# Access Compliance Report Public Rights-of-Way (Curb Ramps)

Main Street: CECIL\_PASTURE\_RD Cross Street: WESTCOTT\_LN Location: NE

ADA ID: RPRK211026124957 Ramp Type: Type 4 - Parallel Initial Pass/Fail: Fail Overall Compliance: No Severity Score: 2

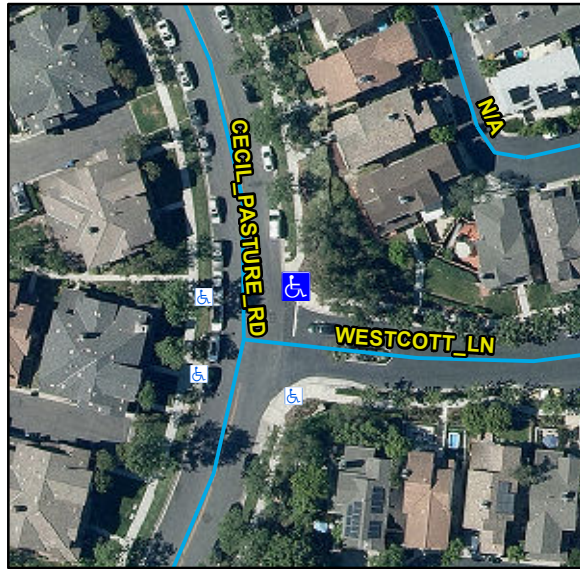
| Compliance | Description                   | Data       | Compliance | Description                   | Data |
|------------|-------------------------------|------------|------------|-------------------------------|------|
| No         | Ramp Cross Slope LT (%)       | 2.1        | No         | Ramp Cross Slope RT (%)       | 3.2  |
| N/A        | Gutter Cross Slope (%)        | N/A        | No         | Perpendicular Joint Present   | No   |

Remove & Replace Curb Ramp With Two New Directional Ramps or Equivalent.

R204.3, R304.5.3, STD 1115
